**BESSIE WELLER ELEMENTARY SCHOOL
SAFE ROUTES TO SCHOOL**
VDOT Project No.: EN16-132-104, C501, P101, R201
FHWA No.: TAP-5132(152)
UPC: 109024

**ADDENDUM NO. 3
October 7, 2019**

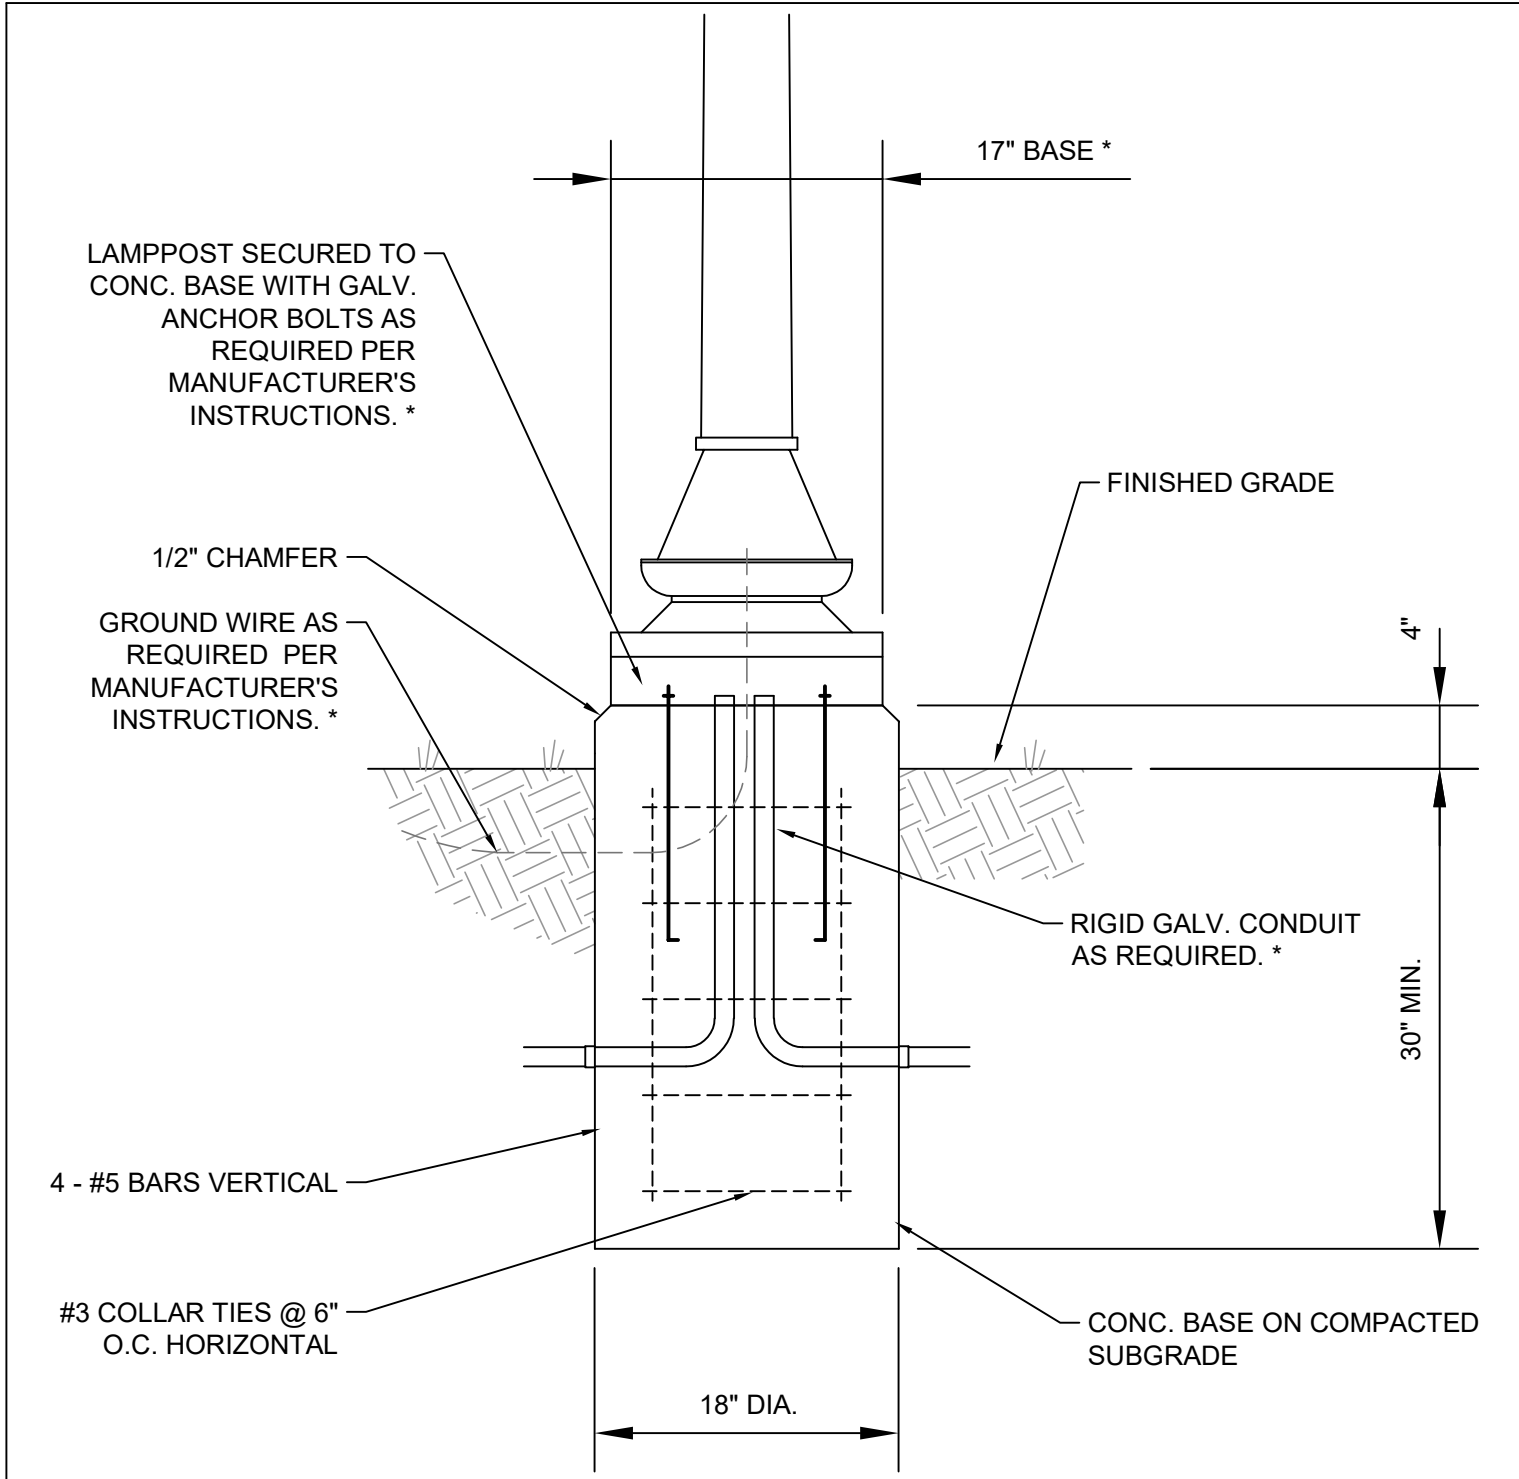
Item 3 - 17 #1 APS? What VDOT Specification for the RRFB? Or is this just pertaining to the PA-3 Mounting requirements?

A detail is attached to this Addendum showing the PA-3 mounting. RRFB shall be TS-60 RRFB as manufactured by Traffic Safety Corporation or approved equal, with MUTCD signage specified on the Plans. A screen shot of the desired configuration is shown below.

R7-1 NO PARKING

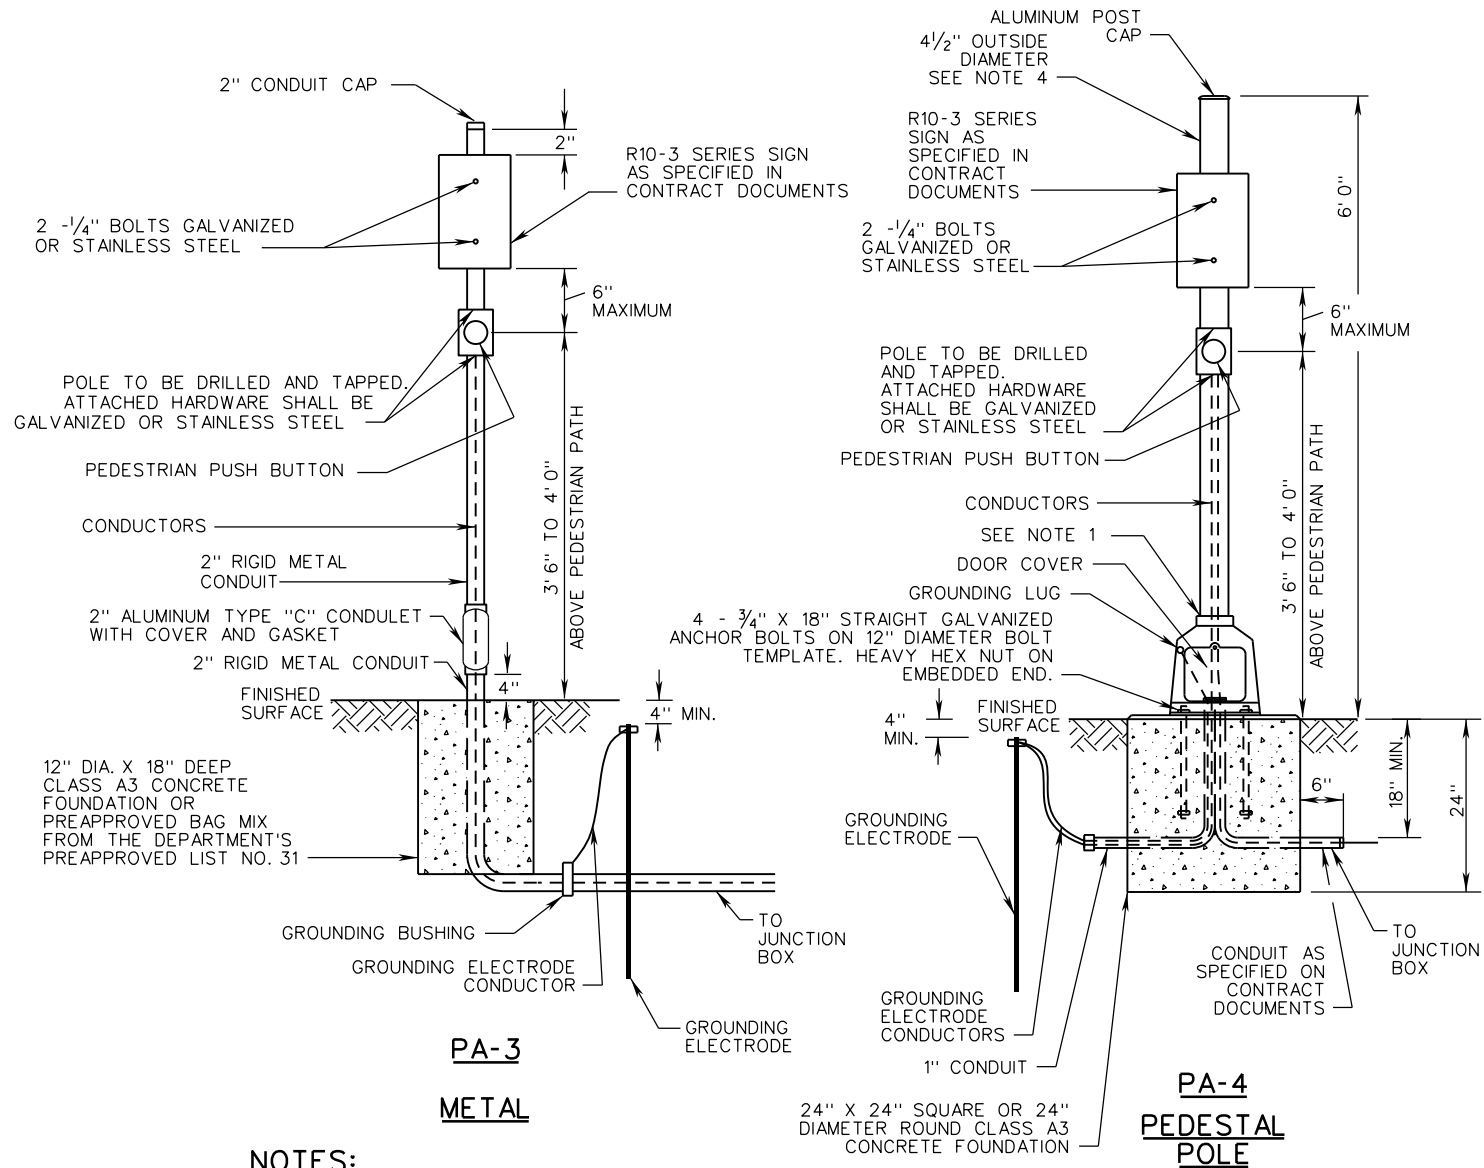
- See Addendum Number 2.**
- Item 3 - 5 Provide specification for new "No Parking Sign" along with post size and foundation requirements.
- FHWA R7-1 is the detail required and is attached to this Addendum.**
